Subject: **Docket No. 50-361**
Response to Request for Additional Information (RAI 54)
Regarding Confirmatory Action Letter Response
(TAC No. ME 9727)
San Onofre Nuclear Generating Station, Unit 2

Response to RAI 54

Figure 4-13 – Tube-to-Tube Wear Rate as a Function of Wear Index

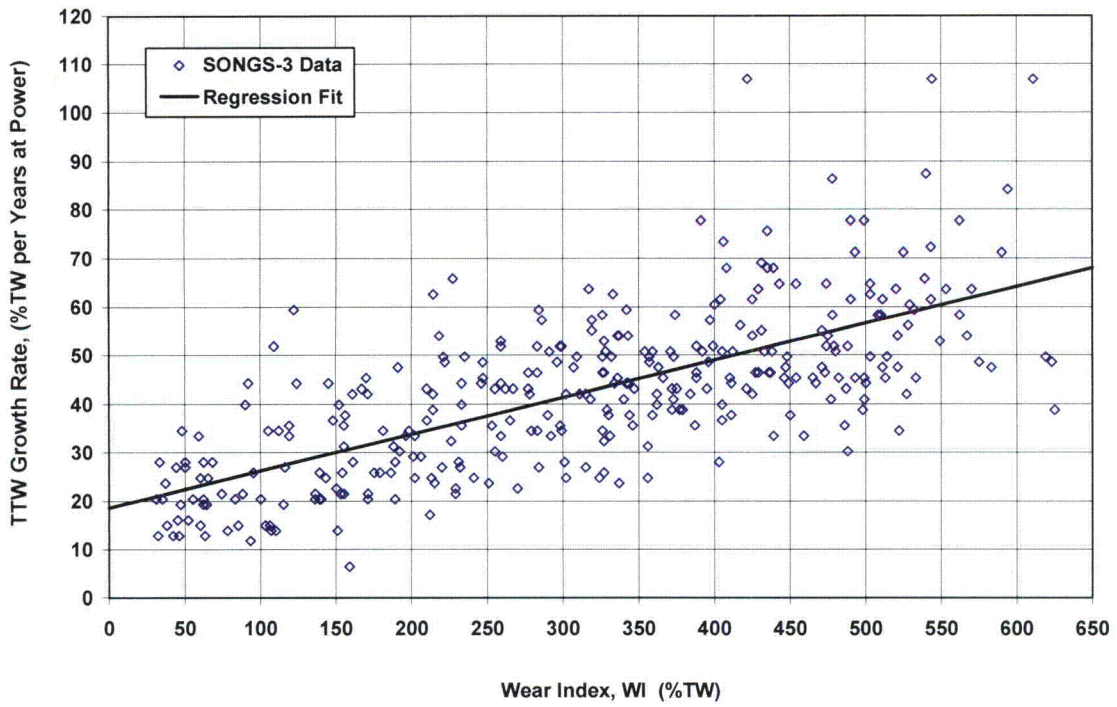
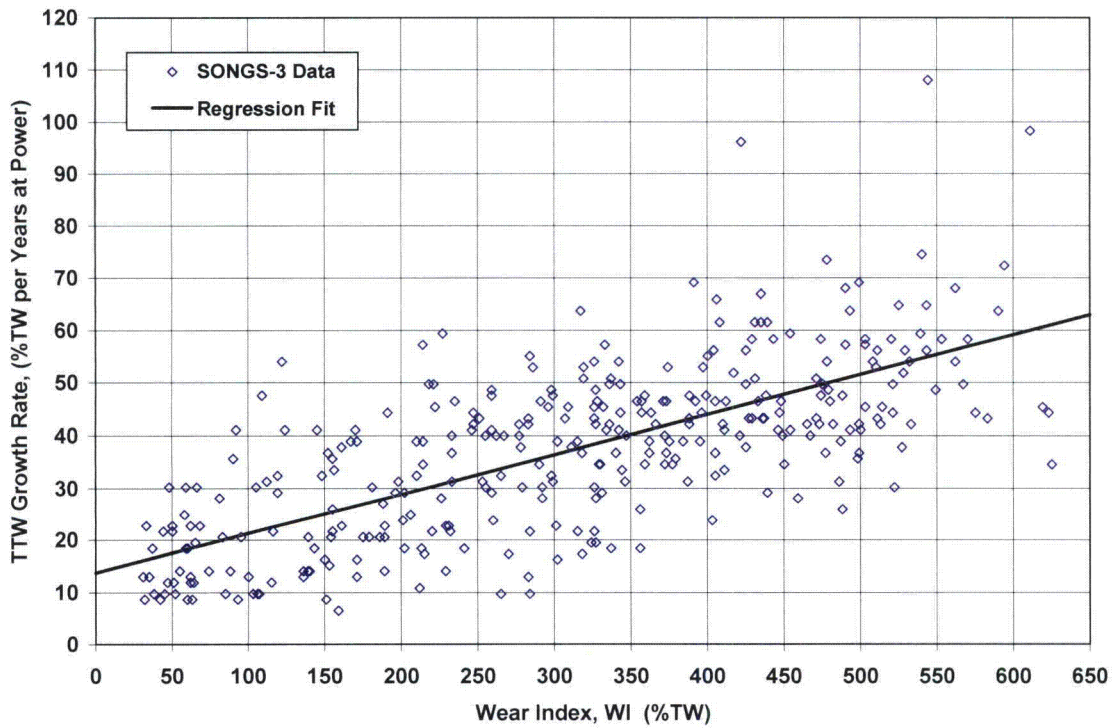
In Reference 1, Figures 4-11 and 4-13, the maximum depths in Figure 4-11 have been divided by the Unit 3 cycle length of 0.926 years to yield the growth rates in Figure 4-13. The staff understands that Figure 4-13 should be simply a scaled version of Figure 4-11. Please explain why some of the data in Figure 4-11 are not shown in Figure 4-13; for example, the three flaws shown in Figure 4-11 with maximum depths ranging from 89 to 100% (AREVA resized).

The wear rates shown in Figure 4-13 were computed by dividing the tube-to-tube wear (TTW) maximum depths by the operating cycle length. The Staff is correct to state that Figure 4-13 is simply a scaled version of Figure 4-11 in RAI Reference 1. A few data points for corresponding wear rates fell above the 100% through wall (TW) per years at power. Figure 4-13 has a vertical axis range of zero to 100% TW per years at power so these points are not seen. Attached are the same graphs in Figure 4-13 with the wear rate axis extended to 120% TW per years at power. The three data points mentioned in the RAI are now visible.
